SUBJECT: Savannah River Site's Responses to the Regulatory Comments on the Calendar Year 2022 D-Area Oil Seepage Basin Operable Unit (631-G) Groundwater Mixing Zone Letter Report, SEMS Number: 27 (RDDD-23-019, Dated July 25, 2023)

SRS Responses to the United States Environmental Protection Agency
Comments on the
Calendar Year 2022 D-Area Oil Seepage Basin (631-G) Groundwater Mixing Zone Letter Report,
SEMS Number: 27, RDDD-23-019, July 2023,
Savannah River Site, Aiken, South Carolina
Comments received November 20, 2023

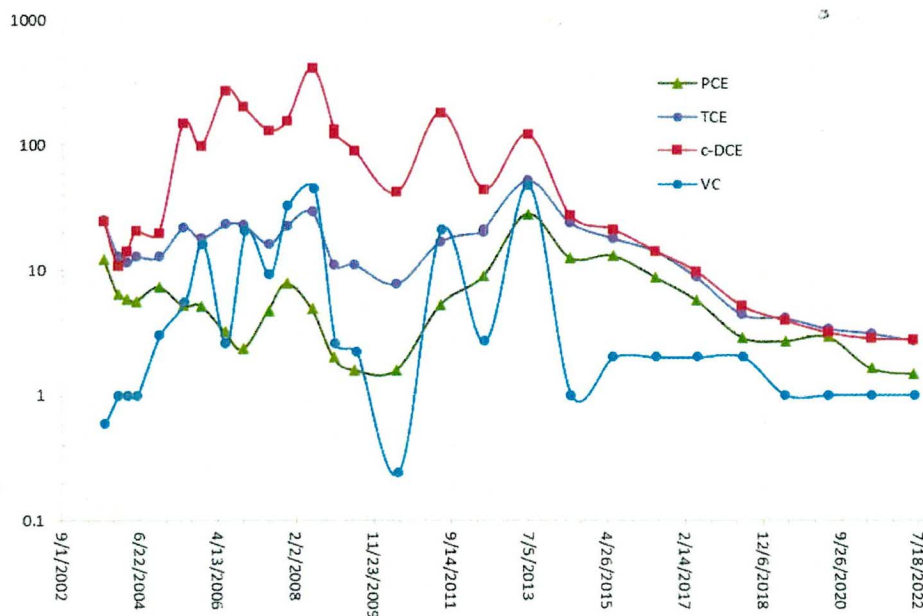
1. **2022 Data Analyses, Page 4:** The last paragraph in the text on Page 4 discusses the trends in wells DOB 12 and DOB 11; however, a trend graph for DOB 12 was not provided in the Letter Report. A trend graph should be provided for DOB 12 to support the statement that DOB 12 has displayed decreasing concentrations in the last eight years. *Please revise the Letter Report to include a trend graph for DOB 12.*

Since the 2022 submittal was a summary level letter report, trends for only a select few wells were plotted. Time series plots for DOB 12 and other wells are provided in the full report from 2021 and can be referenced to support the text in the 2022 letter report. For reference, the time series plot for DOB 12 has been updated to include the data from 2022 and provided below. It can be observed that the analyte concentrations continue to show a decreasing trend. In future submittals of the report, SRS will take care to provide relevant reference to the data in the text. No changes are proposed for the 2022 letter report.
